EPC Package for Singrauli STPP Stage-III (2x800 MW)

S No	BID SPECIFICATION				SPECIFICATION REQUIREMENT	Pre-Bid Queries/ Clarifications	Reply
	Section	Sub-Section	Page No.	Clause No.			
27	SECTION – VI, PART-F	SUB-SECTION-VI CHAPTER -01	PAGE 5 OF 39	1.05.00 Fans A. ID Fans Sl no:10.0	ID fan impeller liner	Impeller liners and Casing liners are not applicable for Axial Reaction ID Fans as per bidder's design practise followed in all the super-critical 660 MW, 800 MW TPP's executed by bidder's for NTPC. These spares are applicable for Radial ID Fans offered in Sub-critical 500 MW Projects. Accordingly, no item is offered against this clause in the previous super-critical 660MW, 800 MW TPP projects of NTPC executed by bidder's. NTPC may please modify the requirement including the clause with "if applicable" similar to amendment issued for SCCL 1x800 MW tender or else delete this requirement. This amendment is critical for smooth execution of contract as functionally equivalent spare item cannot be offered against this requirement.	Bidder to refer Amendment no SG.18 and SG.19 in this regard.

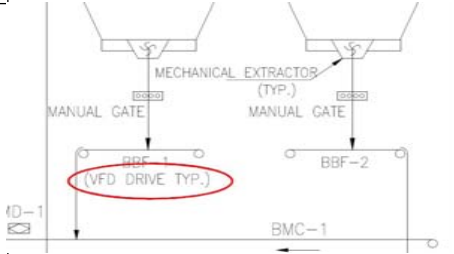
102	SECTION-VI, PART-E	LIST OF TENDER DRAWINGS	PAGE 14 OF 130	ROAD LAYOUT DRAWING		1. In flow diagram, ERH conveyor numbering is mentioned as conveyor 36 whereas in plot plan it is shown as conv.39, bidder is considering the numbering as conveyor 36, kindly confirm.	Bidder to refer Sl. No MH-8 amendment no 1 to technical specification.

2. Existing cable/pipe racks are fouling with the proposed conveyor 36 in the layout. If these cable/pipe racks are to be dismantled, kindly clarify as to whether this dismantling, relocation and re-erection of cable/pipe racks along with equipment is in NTPC's scope or Bidder's scope? If it is in bidder's scope, plant shutdown has to be provided by NTPC, as per bidder's requirement.

3. In addition, this conveyor has interface with existing conveyor and some other unnamed facility on the right side of newly proposed coal crusher house (as circled in red), so NTPC to kindly furnish the drgs. of existing conveyors and unnamed facility as marked for interface & feasibility check. Pl. clarify and confirm.	
103	SECTION-VI, PART-E	LIST OF TENDER DRAWINGS	PAGE 9 OF 130	GENERAL LAYOUT PLAN	CRUSHED COAL STOCKPILE	Due to layout constraints and feasibility, length of each of the three proposed Crushed coal stockpiles shall be limited to 235m, with which 17 days storage requirement cannot be met. So customer to kindly accept the same.	Bidder to refer Sl. No MH-5 amendment no 1 to technical specification.
	SECTION-VI, PART-B	SUB SECTION-A-01 EQUIPMENT SIZING CRITERIA	PAGE 85 OF 92	4.02.12	Bidder to maximize the coal stockyard storage capacity by utilizing the available space. However, stockyard capacity in any case shall not be not less than 17 days considering 800T/m3 bulk density of the coal.

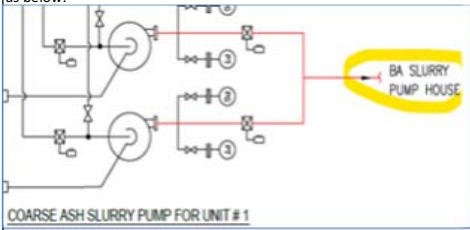
Customer to kindly note that the proposed conveyors of Stage-III are crossing the conveyors of Stage-I & II, GA drawings of these conveyors at crossing may please be provided to check the conveyor profile and space feasibility for stage-III	Bidder to refer Sl. No. MH-1 amendment no 1 to technical specification.
